13 January 2020

Project No. 1523677-010-L-Rev0

LANDSLIDE RISK ASSESSMENT, DEVELOPMENT PLAN VERSION 36, 6230-6280 GREAT OCEAN ROAD, APOLLO BAY, VICTORIA

Date: 28.10.19
 Version No: 36
 Job No: 3313
 Scale (A1): 1:1500
 (A3): 1:3000

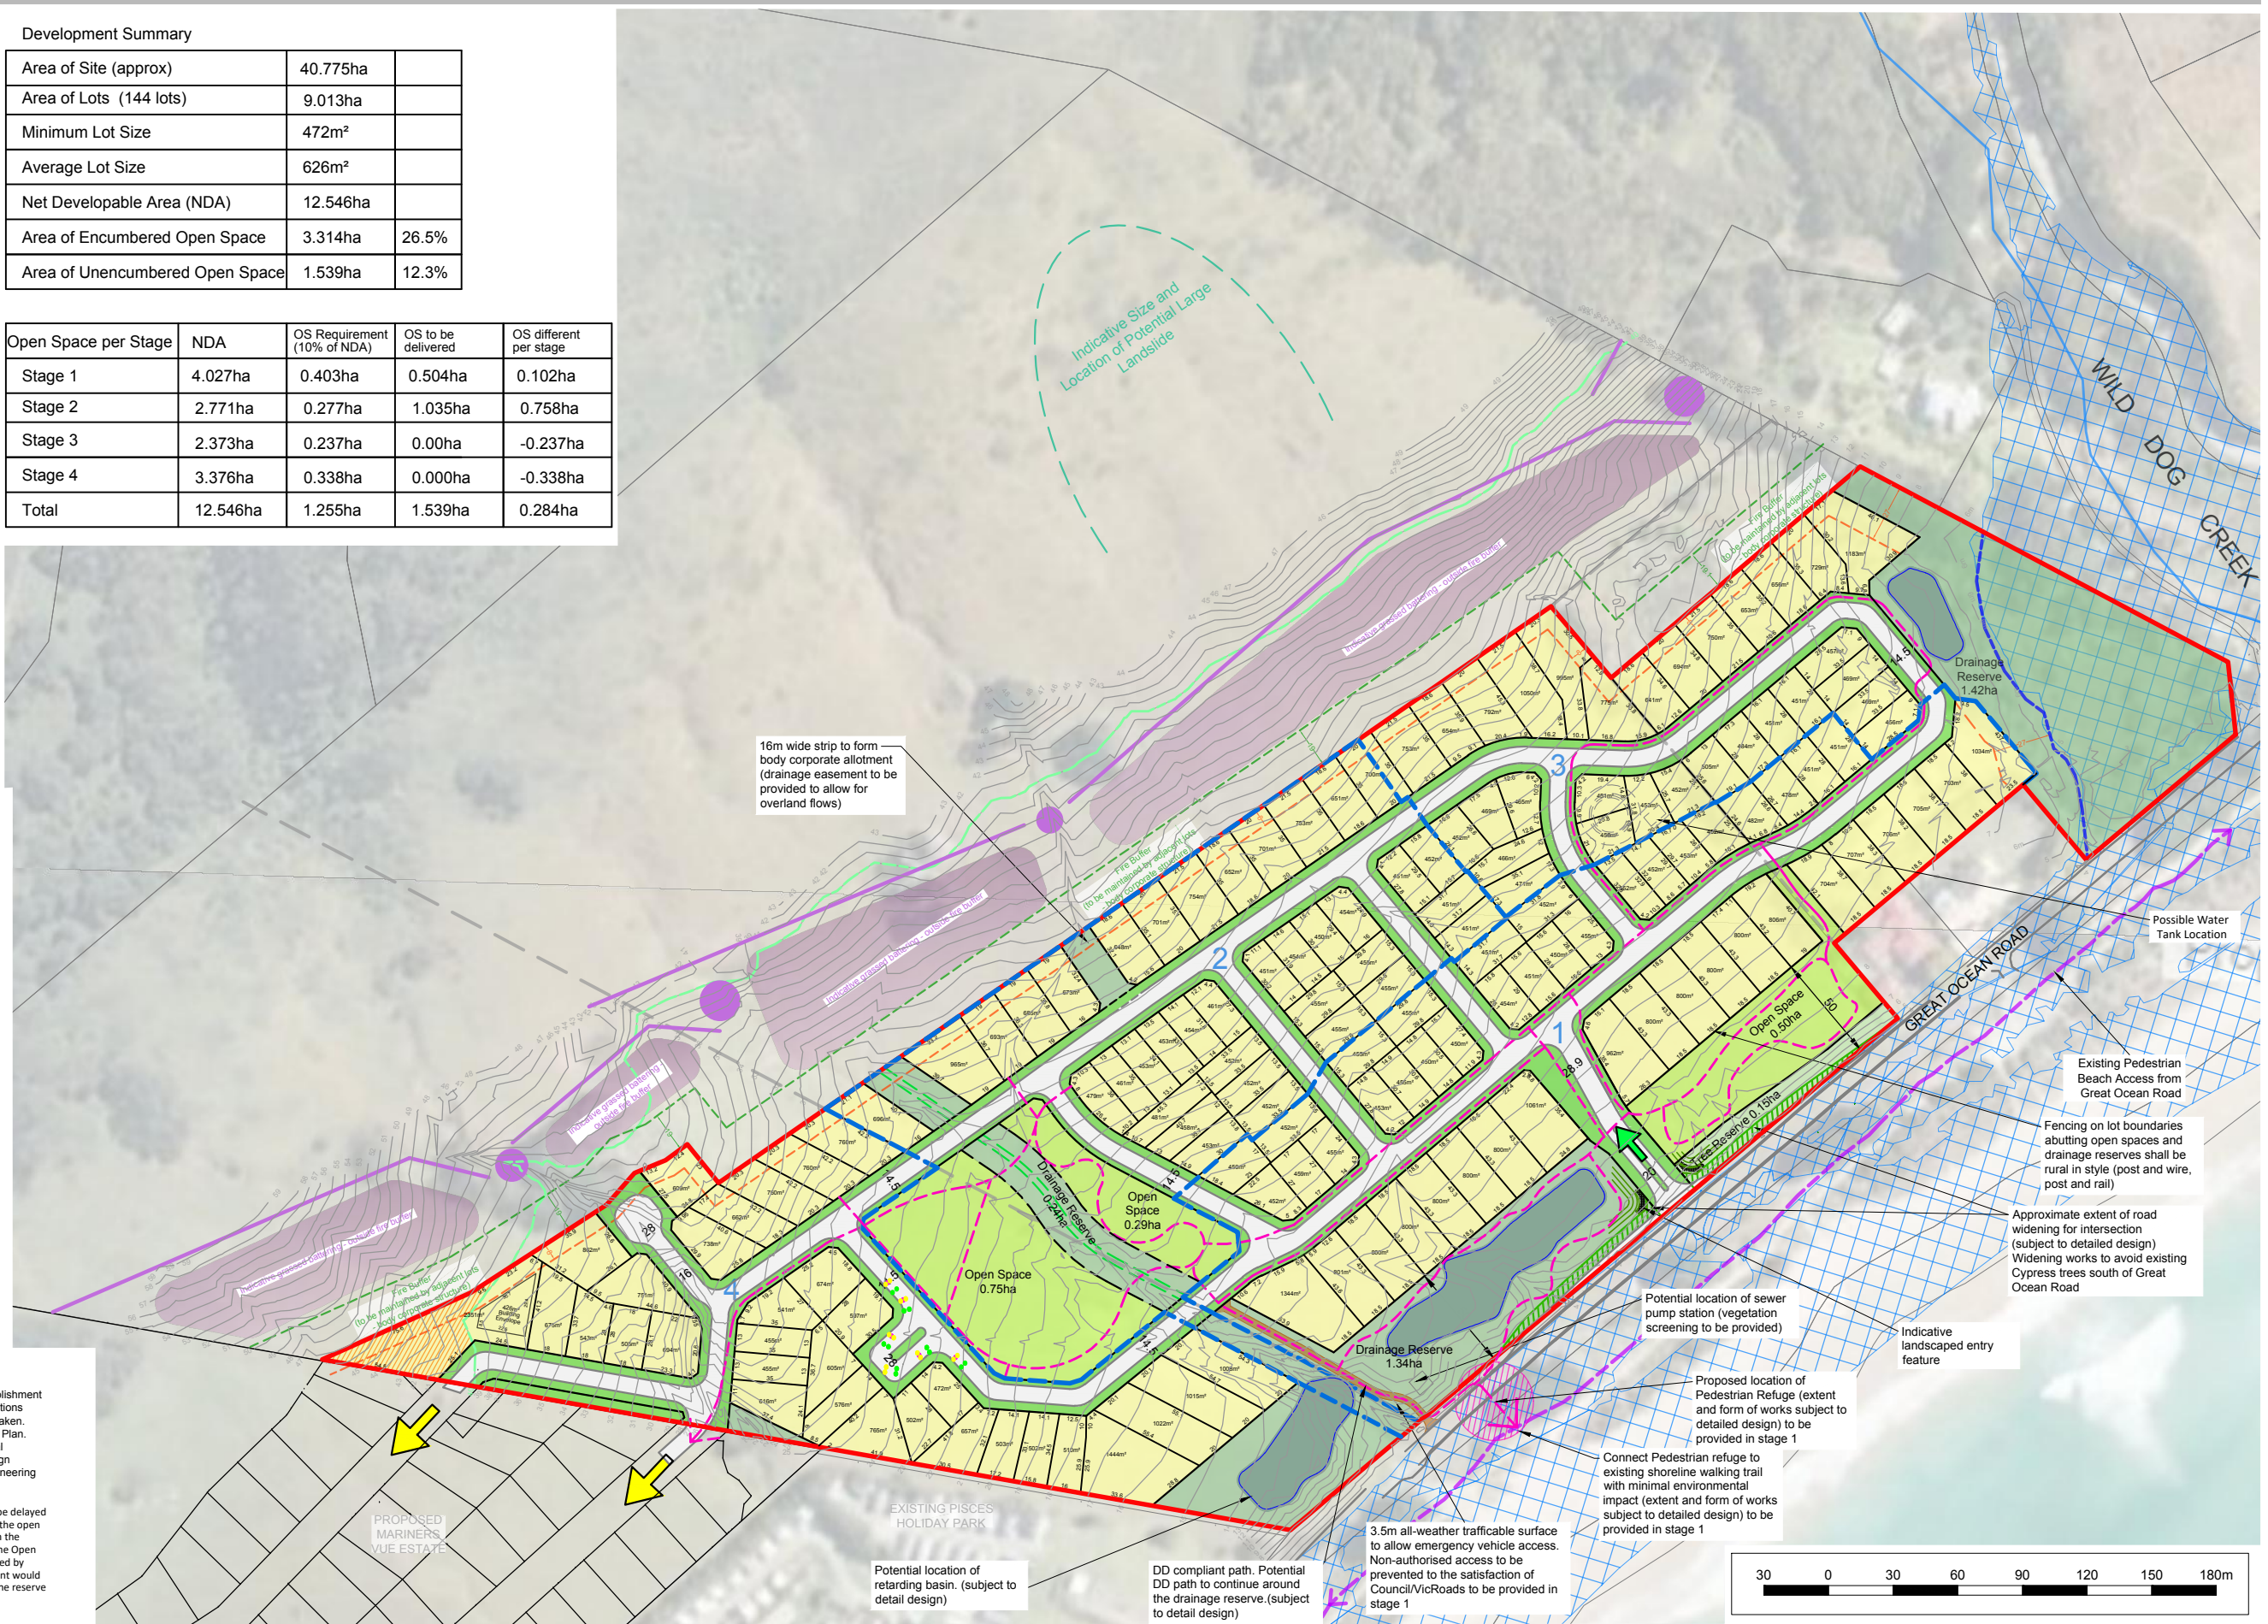
Overall Development Plan Version 36 has been provided by Beveridge Williams. The location and configuration of the residential lots within Version 36 appears to be similar to Version 28, which was assessed by Golder previously. There appears to be an increase in open space/drainage reserve on the southeast boundary (Great Ocean Road frontage) of the development site, with an associated reduction in the extent of the residential lots in that area. Those changes on the southeast side of the proposed development do not change our previous assessment of landslide risk for the development.

The configuration of the earth bunds in Version 36 also appears to be similar to Version 28.

The intent of the indicative location of the earth bund is to divert landslide material travelling down the hill slope, away from the proposed residential development lots. Although it is unlikely that landslide material would travel far, the intent of the bund is to intercept and retain mobile landslide material along the uphill side of the bund and potentially under extreme conditions to direct run out into open space below the bund such as drainage or road reserves (lower risk locations than the residential lots), with channel flow breakers in gaps between the bunds to assist with the dissipation of the landslide energy.

In our opinion, the bunds/channel flow breakers located as shown in Overall Development Plan Version 36 are consistent with the bunds/channel flow breakers located as shown in Overall Development Plan Version 28 and the risk to life or property in the proposed development would be similar.
